Addendum

SPRINGS AT FREMAUX TOWN CENTER
SLIDELL, LA

PHILLIPS JOB NUMBER 1333104
ISSUE DATE 07/07/14
DRAWN BY/CHECKED BY ATL/DEB
DRAWING TITLE UNIT 2GC FLOOR PLAN, ELEVATIONS & DTLs.
SHEET NUMBER A4.2GC

UNIT 3GC
FLOOR PLAN,
ELEVATIONS & DTLs.
 SHEET NUMBER

UNIT 3GC - PLUMBING PLAN

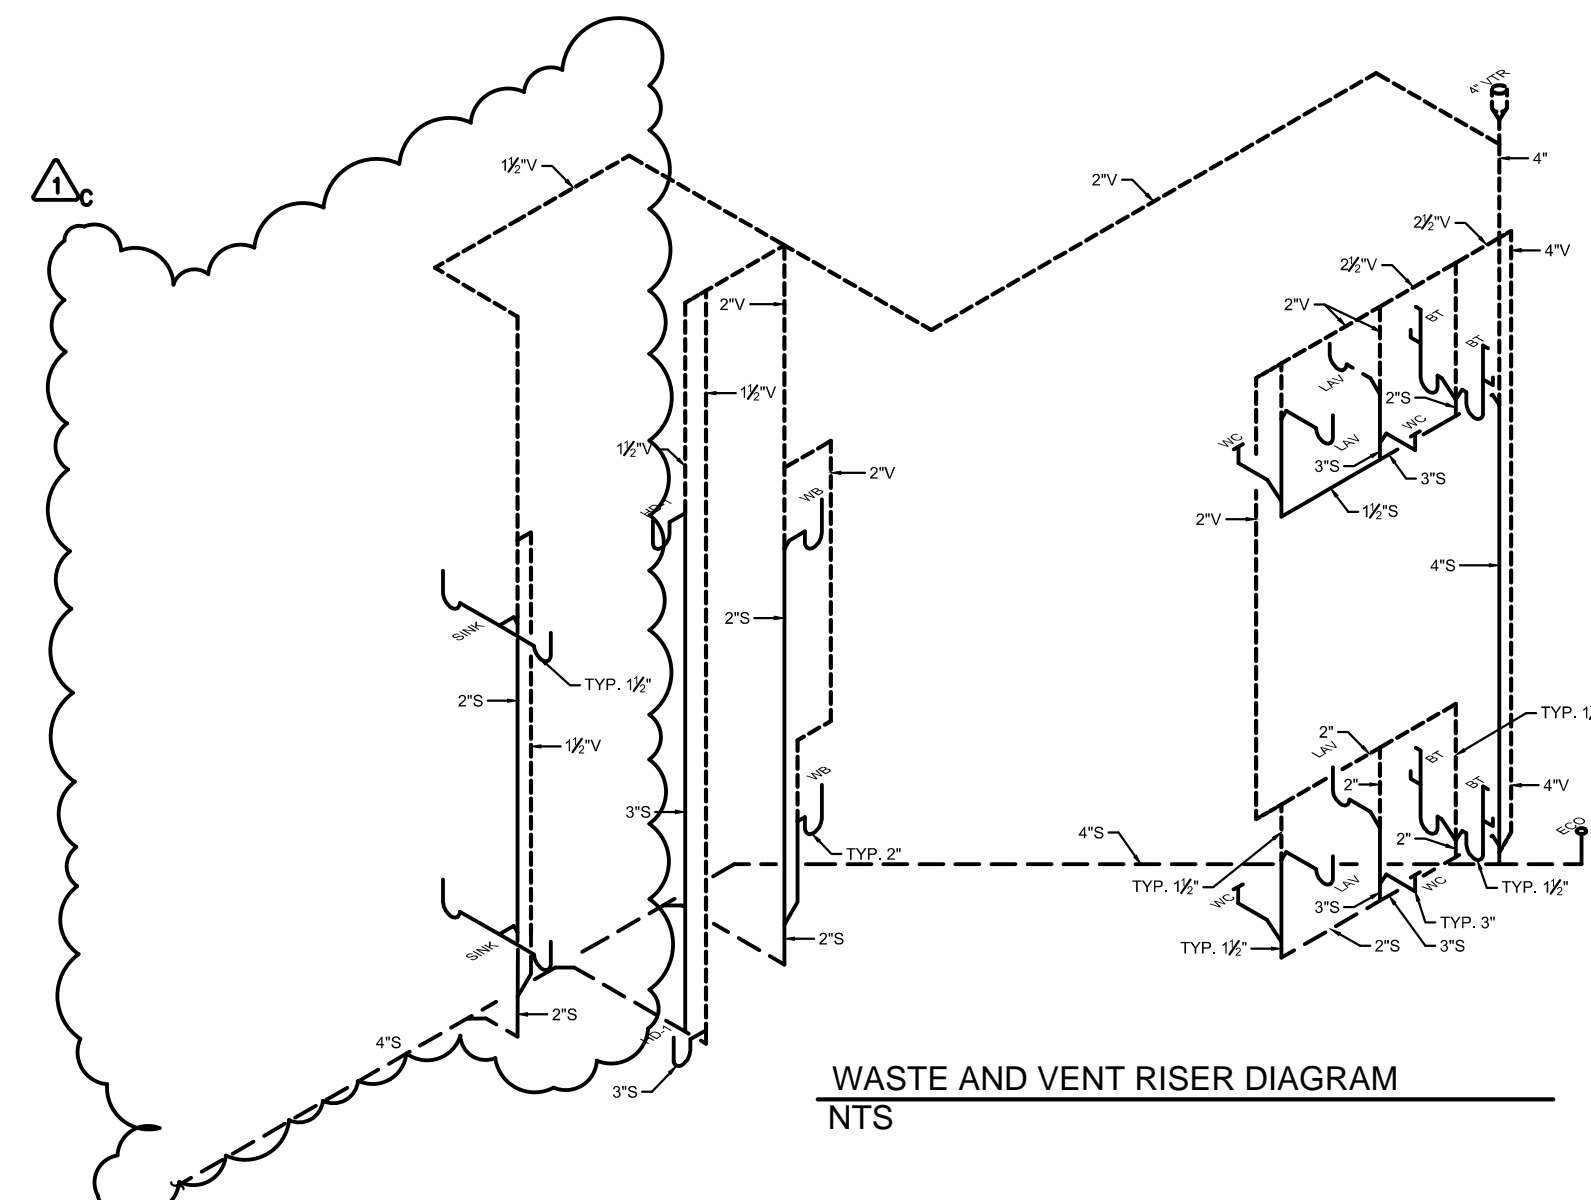
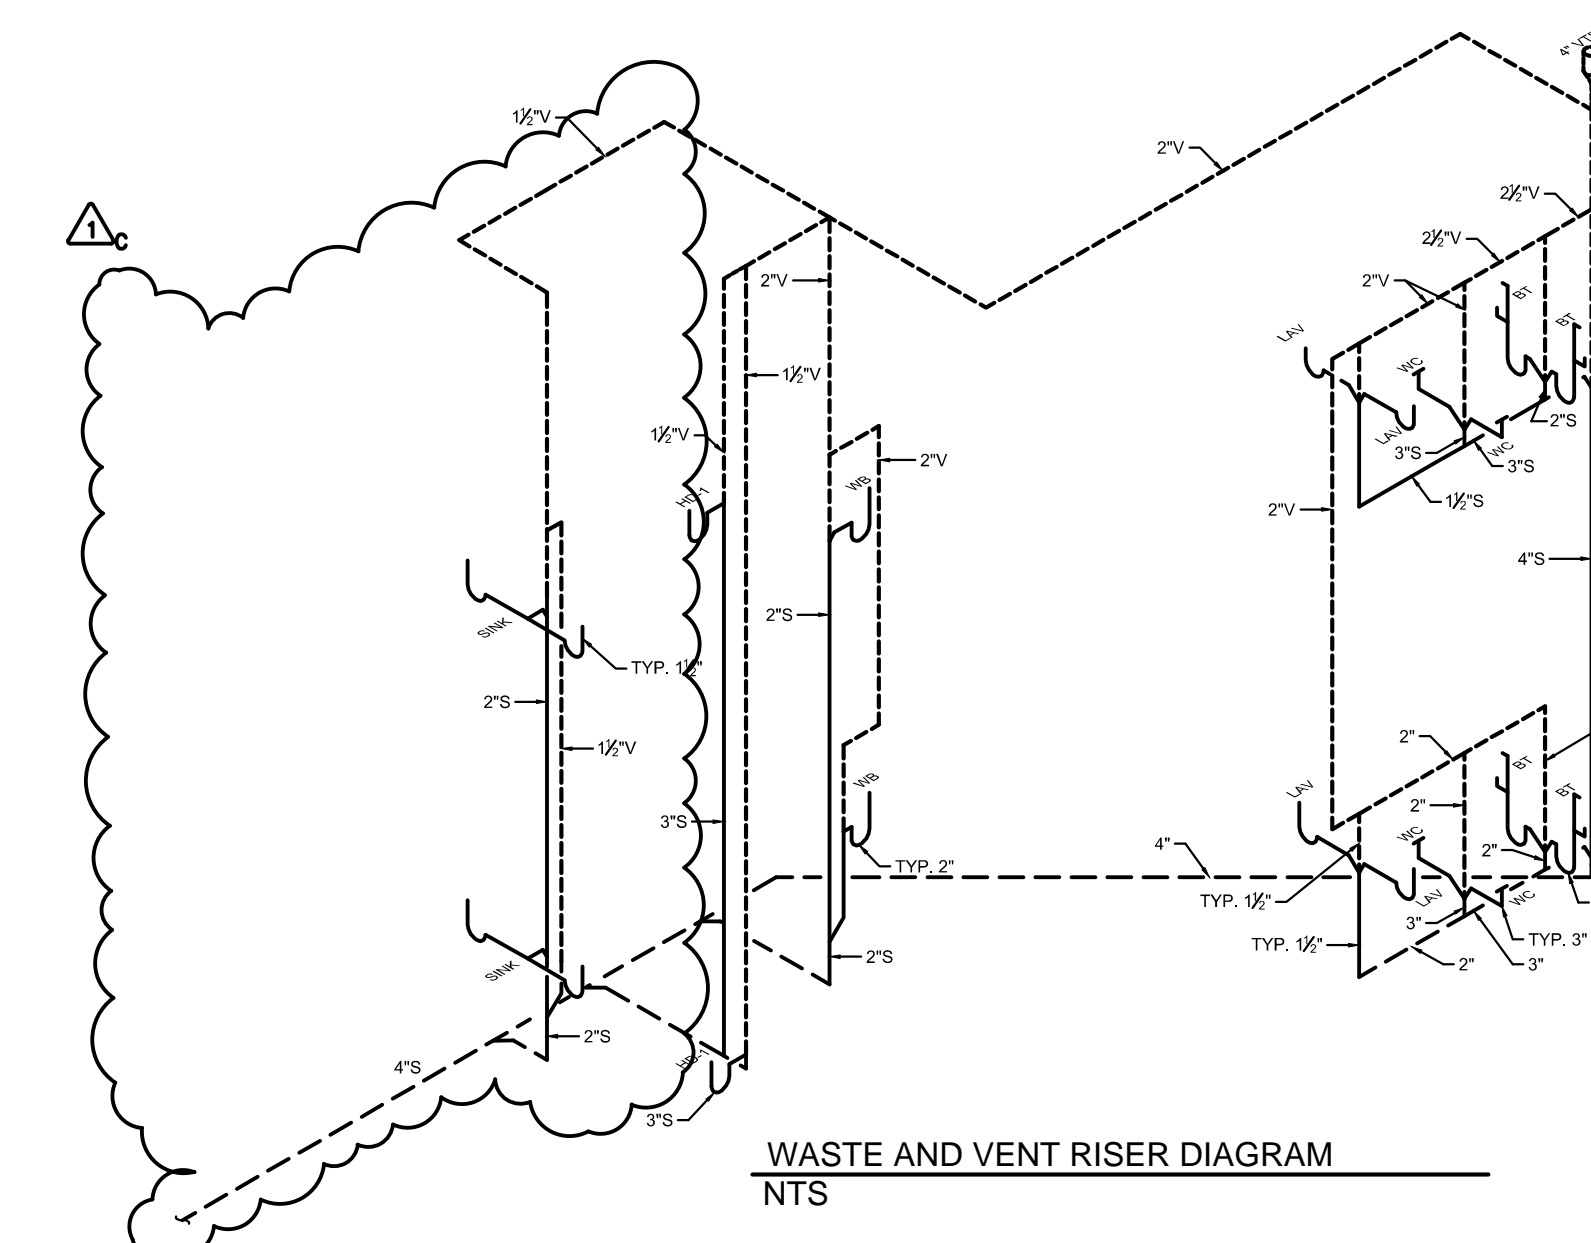
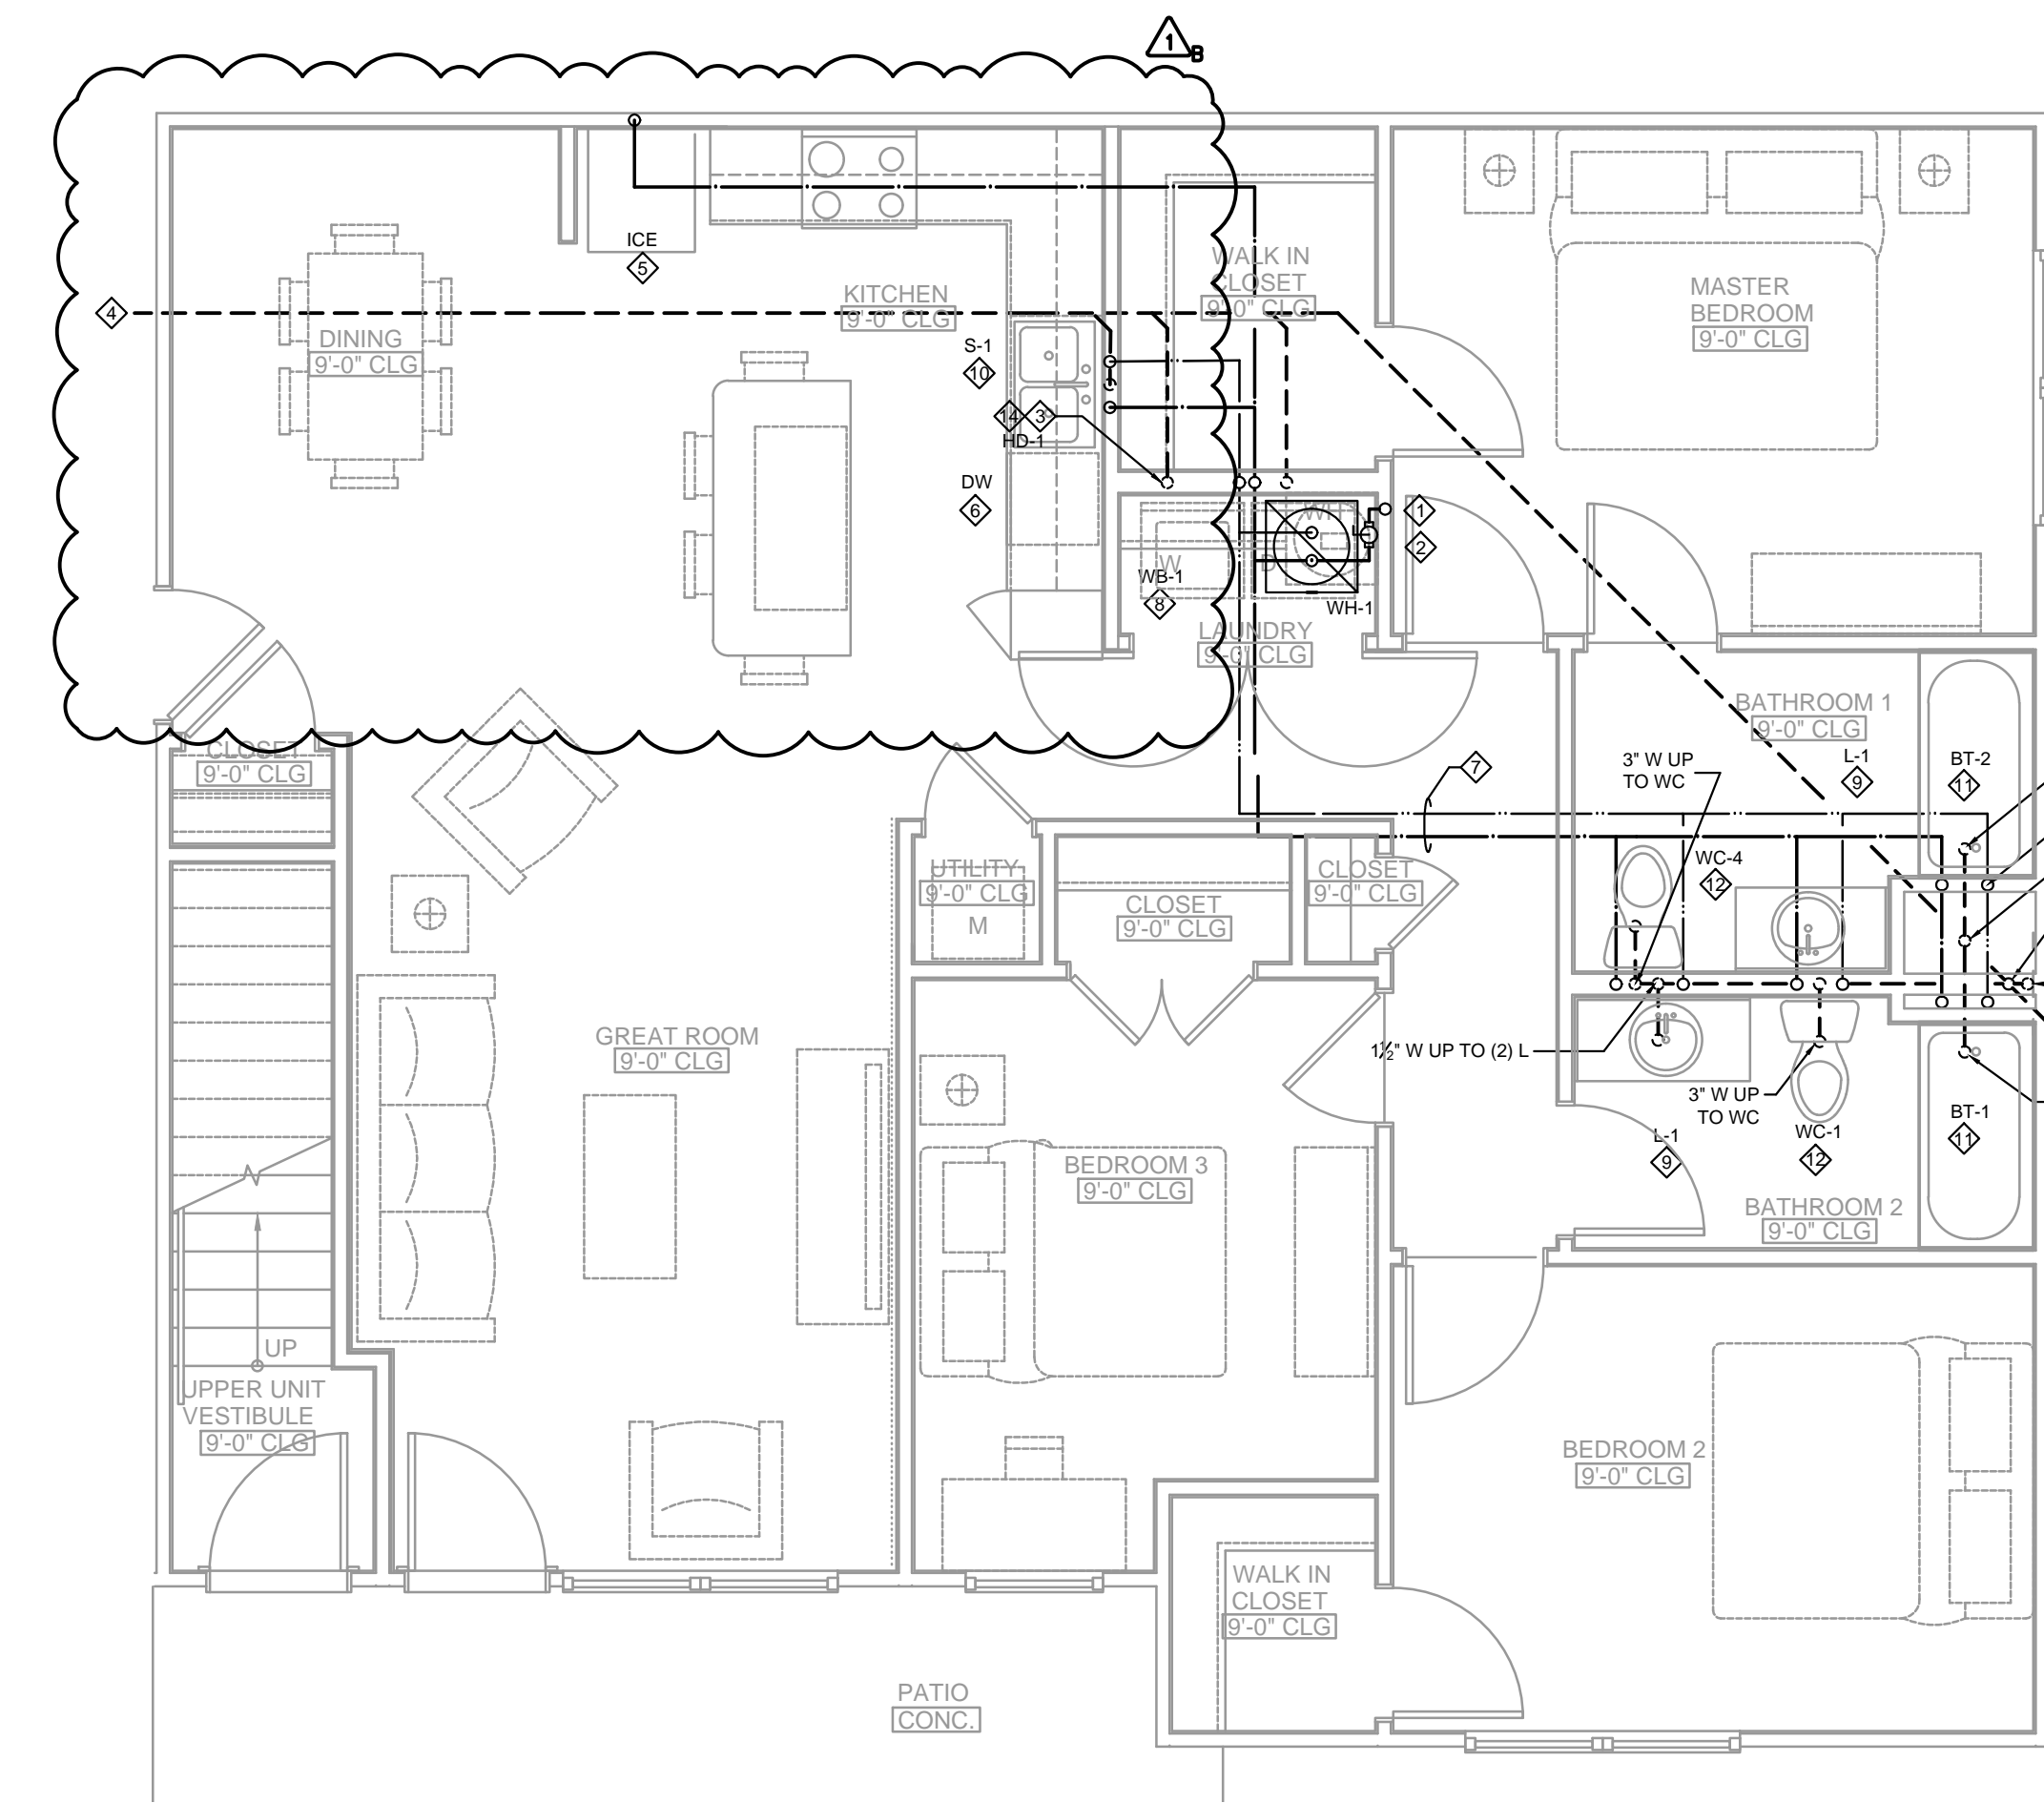
- A. REVISED NOTES.
- B. REVISED BASE.
- C. REVISED RISER DIAGRAMS
